### ADDENDUM NO. 2

Invitation to Bid (ITB) 26-20-214605

Bridge 106.2 Handrail Repair

Alaska Railroad Corporation

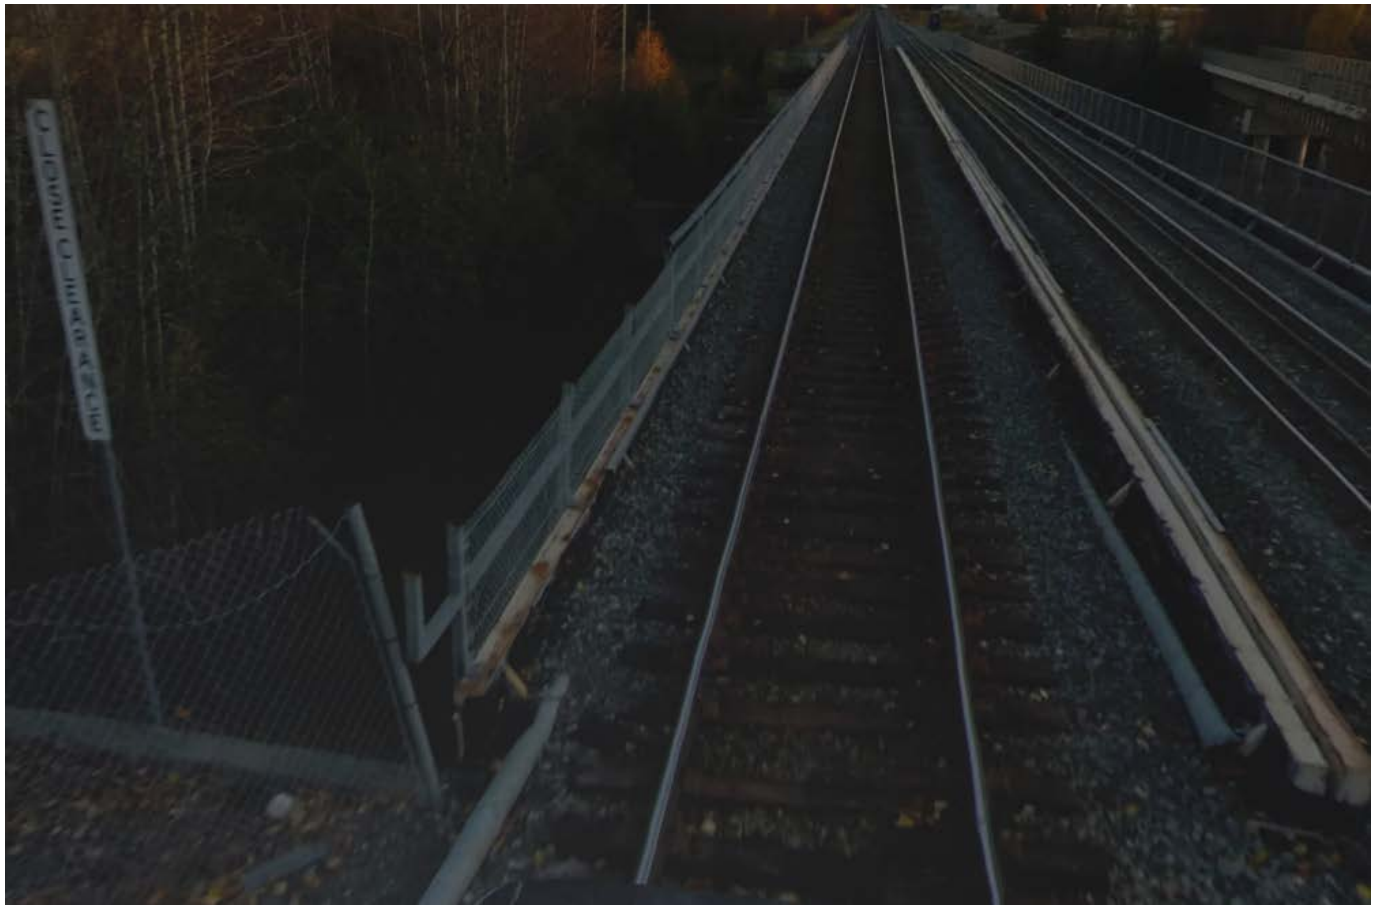
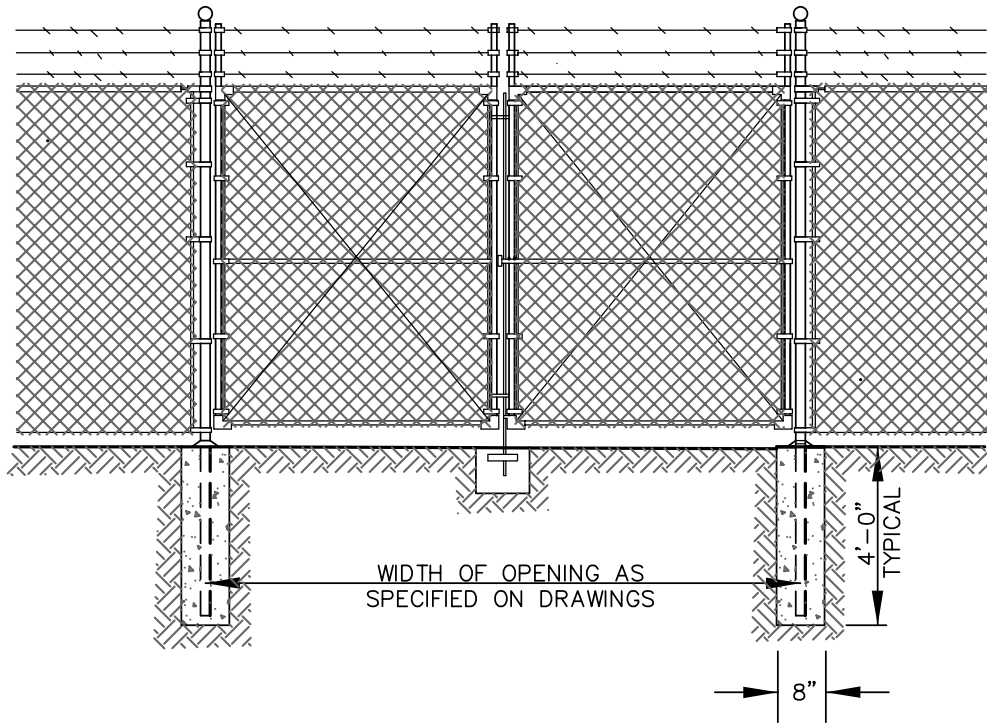
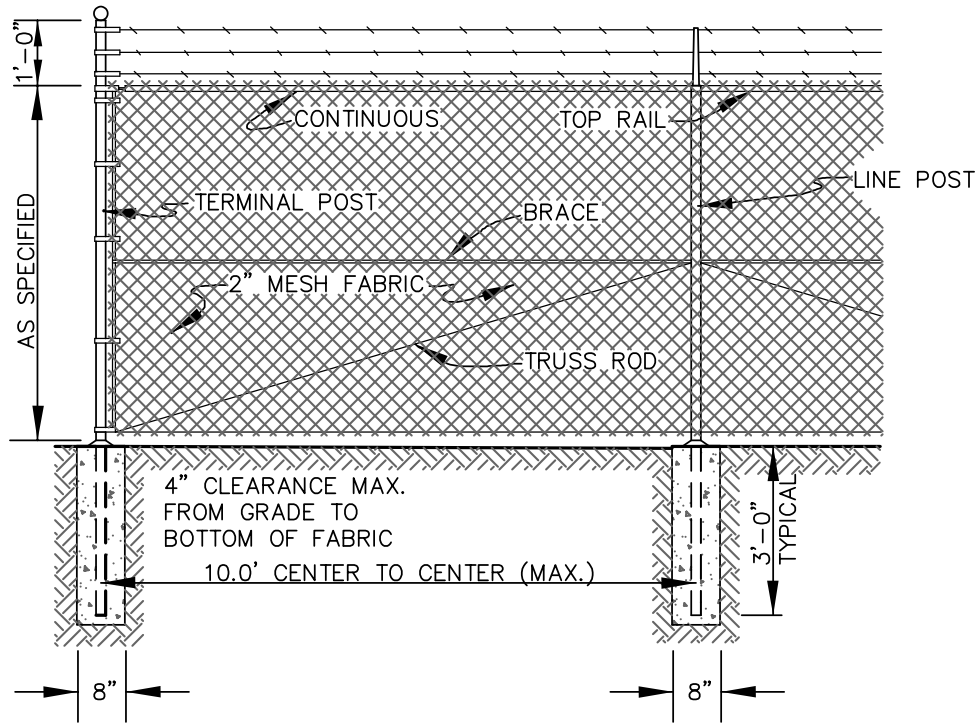
5. Could you provide existing condition photos of the 6-ft chain-link fence off the end of the North-East handrail, described in the SOW?

Yes, see attached: IMG 9701, IMG 5741, MP 106.2 Handrail Damage North East Side Looking South.

DETAIL #  
75-12

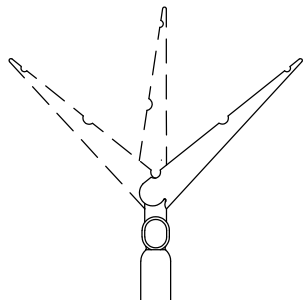
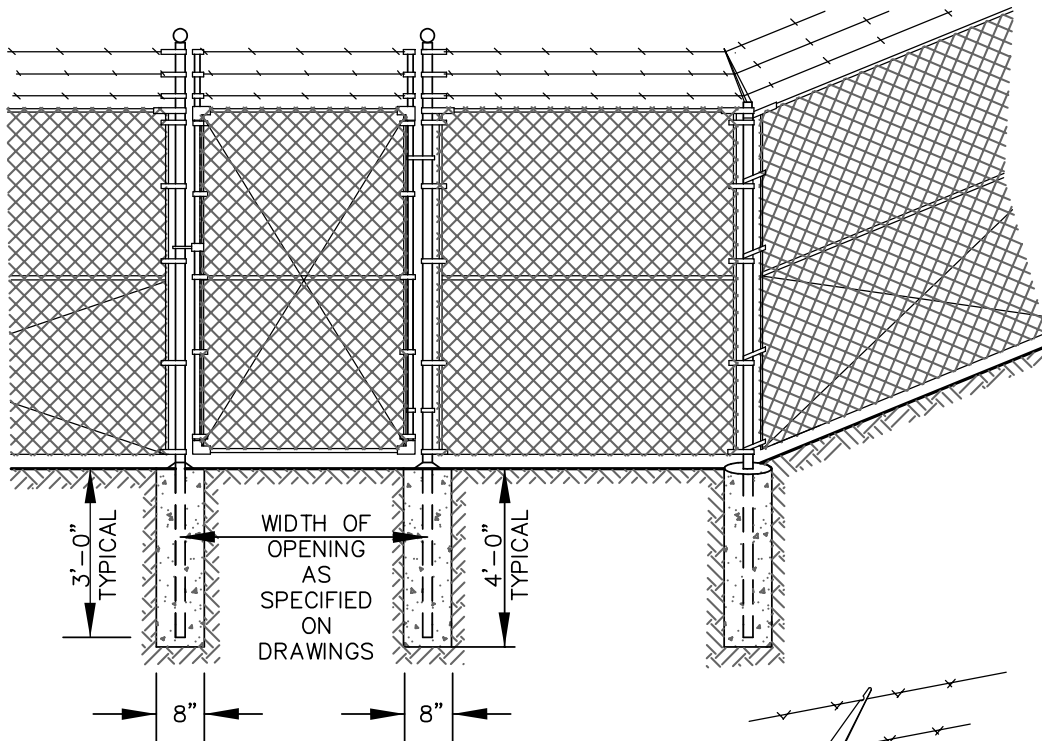
1. The Scope of Work mentions a 6 ft Chain-Link fence that requires removal, replacement, relocation, and repair but there are no details showing what this work will entail. Please provide details of the work required or consider making it a Contingent Sum Item.  
See the following details for this work: Disconnect and preserve the existing chain link fence fabric. Remove and dispose of the damaged fence post nearest to the bridge handrail as shown in the photos and described in the contract documents. Install a new termination fence post, of like material as that removed. The base of this new fence post will be embedded 3-foot into the ground within an 8-inch diameter hole. This hole is to be filled with concrete around the new post. The stick up of the new post shall be 6-foot above grade. The new fence post is to be set vertically and the horizontal offset from the track shall be 4-inches beyond the furthest point of the new adjacent bridge handrail (east-west). The new fence post shall be offset from the concrete bridge abutment by approximately 5-inches (north-south). A new tension rod shall be installed on the existing chain link fabric and new tension bands and hardware shall be used to reinstall and tension the existing fence fabric to the newly installed post. Wire tie shall also be used to reconnect the fence fabric to the nearby fence post, as required. Reference typical Municipality of Anchorage fencing details provided herein.
